Addendum No. 08 INVITATION FOR BID NO.: 11-05 Modernization of Classroom Building 300 – Chabot College

Chabot College Modernization
of Buildings 300 and 500
Chabot-Las Positas Community College District
HMC # 3342002, DSA #01-109151

ADDENDUM NO. 8

GUARDRAIL AT DRINKING FOUNTAIN

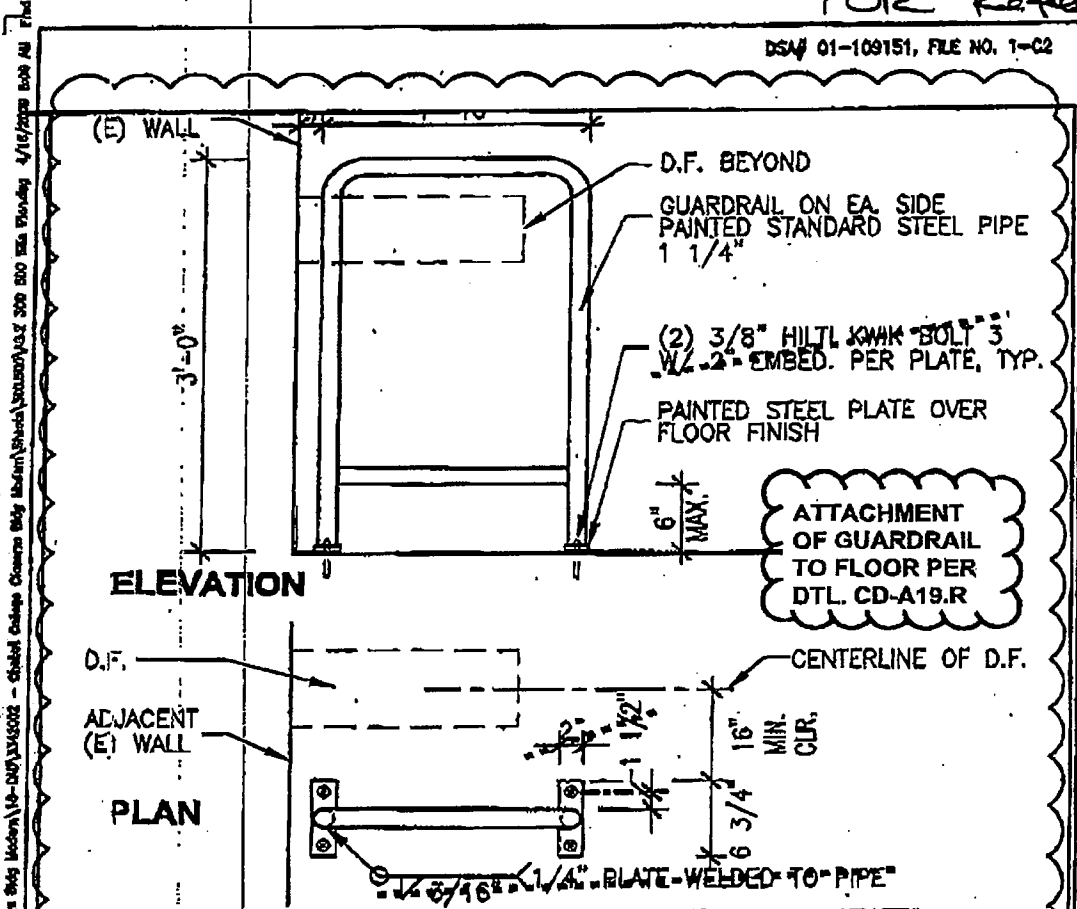
ITEM B-3.1 Provide and install guardrails on each side of the (E) accessible drinking fountains on the 1st and 2nd floor. Refer to the enclosed sketch CD-A1 & CD-A19.R

Justification: Unforeseen condition. These (E) wing walls at these drinking fountains contained asbestos materials therefore were demolished. Guardrails are required for these drinking fountains.

**SSK-1 MECHANICAL PENETRAIONS THRU (E)
 BEARING WALLS REF. RFI 11 3/8" = 1'-0"**

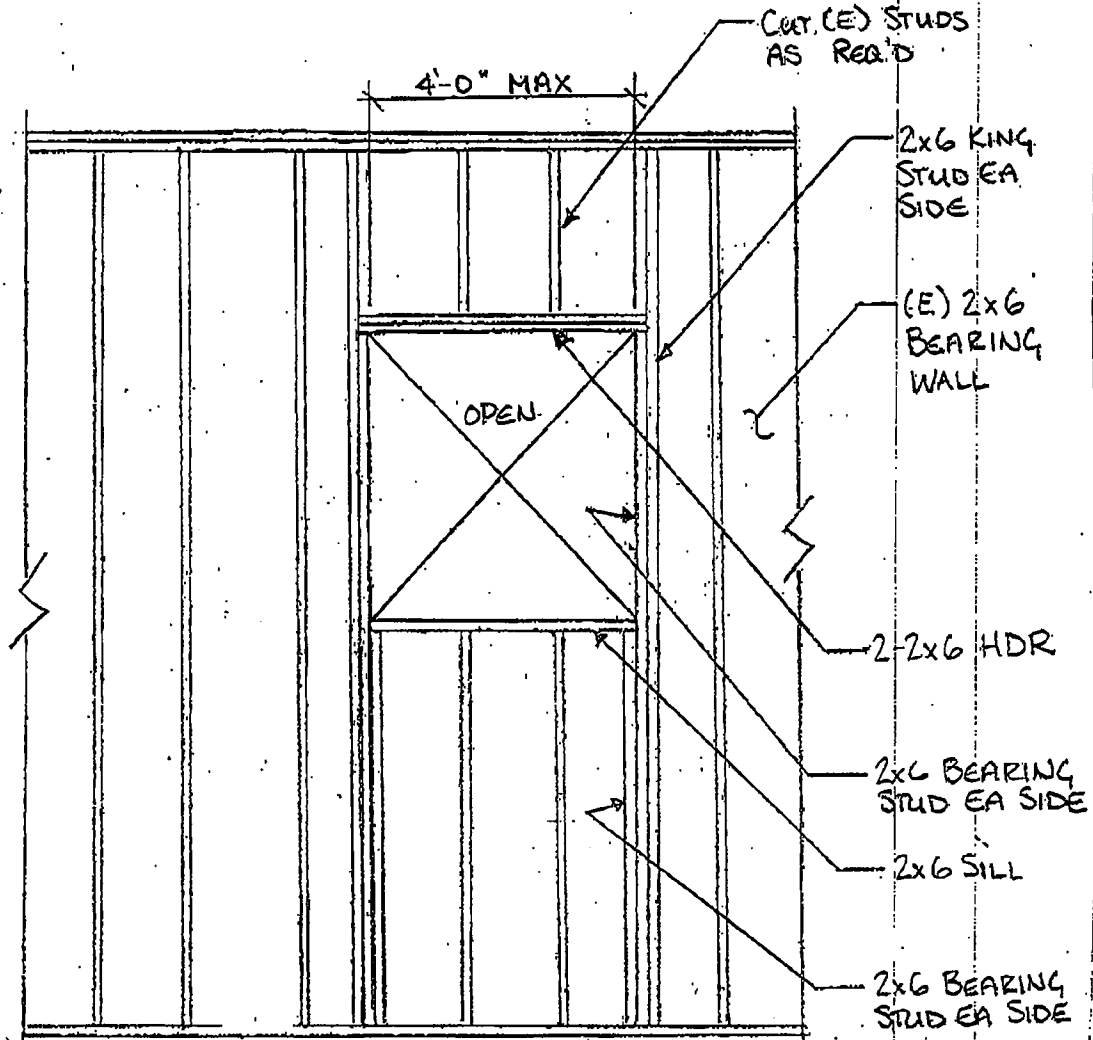
Detail/Drawing No.:	S2.5, 18/S3.3	See Attached:	RFI #2 from RHI
Specification Section:			
Potential Cost Impact:		Potential Schedule Impact:

Please see the attached RFI #2 from Richard Hancock requesting a clarification on the HVAC penetrations through bearing and shear walls.

SEE THE ATTACHED SSK-1 FOR FRAMING AT MECH. DUCT PENETRATIONS THRU (E) BEARING WALLS. THIS DETAIL WILL REQUIRE DSA APPROVAL.

SSK-3 COLLECTOR BEAM SPLICE AT (E) WF BEAM
 REF. RFI 17

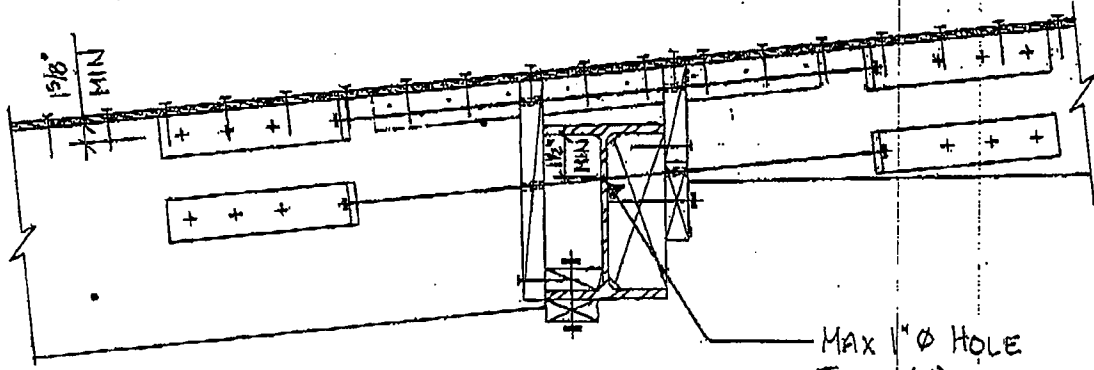
Detail/Drawing No.:	S2.6 Line B	See Attached:	
Specification Section:			
Potential Cost Impact		Potential Schedule Impact

On S2.6, Line B, Gridlines 9 and 9.5 shows the detail 4 on S3.3 at this connection. The actual condition at this location is like detail 19 on S3.2. There is only 2-3/8" space between the steel beam and the plywood roof with no room to run the all-thread to the Hold Downs.

SEE THE ATTACHED SSK-3 FOR THE CONFIGURATION OF THE HOLDDOWNS AT THE (E) WF BEAM. THIS CHANGE WILL REQUIRE DSA APPROVAL.

SSK-4 COLLECTOR BEAM AT (E) 2x STUD WALL
 REF. RFI 20

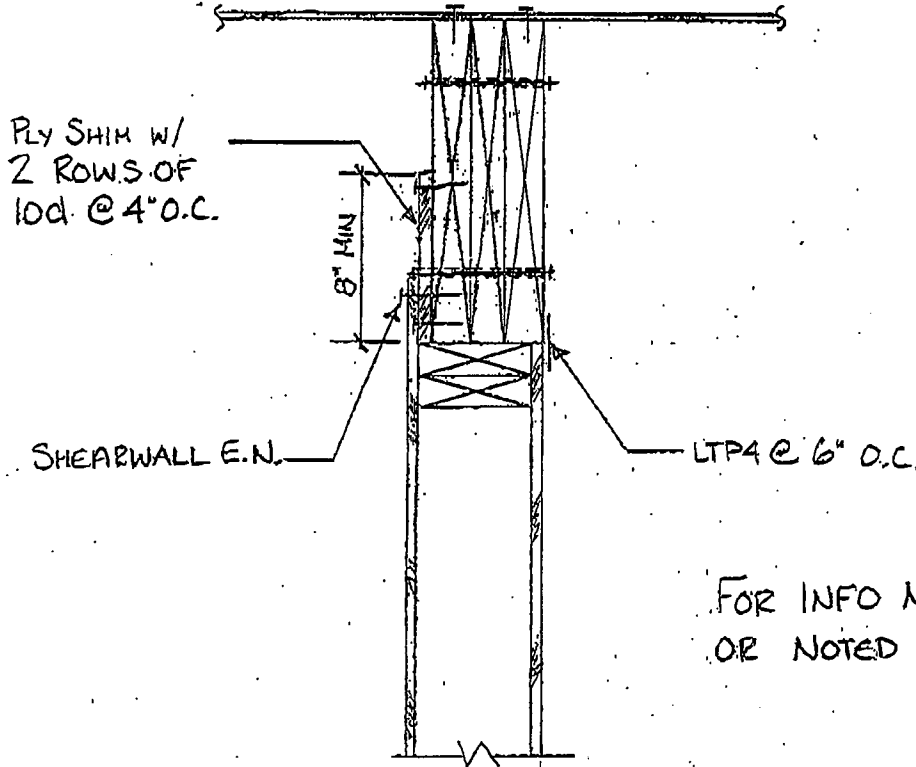
Detail/Drawing No.:	Detail 20 - A / S3.3	See Attached:	
Specification Section:			
Potential Cost Impact		Potential Schedule Impact

When the existing 2x16 is not center on the stud wall and the LVL is hanging over, can we butt the plywood underneath and use LTP4 clips to connect the shear ply to the LVL and other side install a plywood strip to furr it flush to run the plywood past?

SEE THE ATTACHED SSK-4 FOR CONNECTIONS OF THE PLYWOOD TO THE LVLS AT LOCATIONS WHERE THE SHEARWALLS DO NOT ALIGN WITH THE (E) 2x16 JOISTS. THIS CHANGE WILL REQUIRE DSA APPROVAL

SSK-5 SPLICED COLLECTOR BEAM PLAN VIEW
 REF. RFI 24 1/4" = 1'-0"

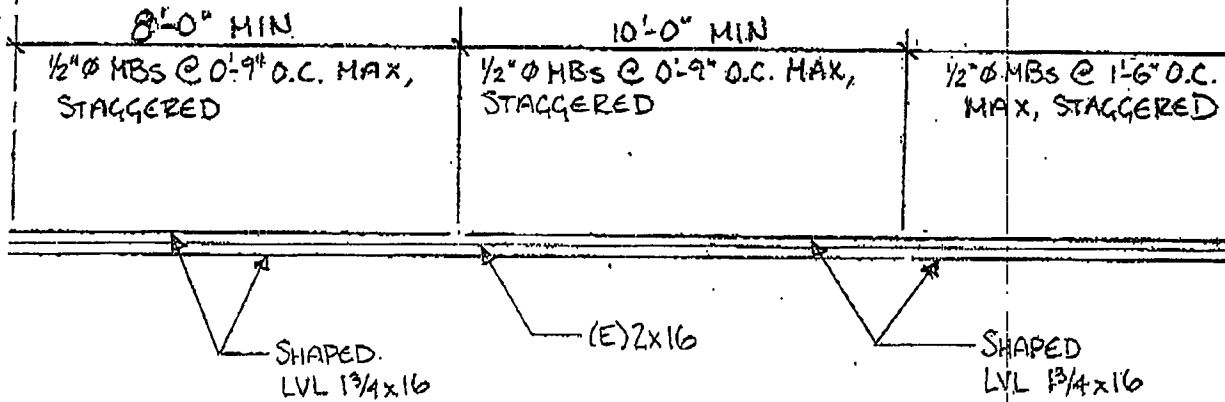
Detail/Drawing No.:	20/S2.3	See Attached:	
Specification Section:			
Potential Cost Impact	YES	Potential Schedule Impact

Can we stagger a splice on the LVL's over a stud wall or in the field in order to achieve proper bearing at exterior or interior bearing walls

SEE THE ATTACHED SSK-5 FOR MINIMUM SPLICE LENGTH, MINIMUM DISTANCE FROM HOLDDOWNS AT GRIDLINE (B)/(C), AND DECREASED 1/2" Ø MB SPACING. THESE CHANGES ARE PENDING DSA APPROVAL.
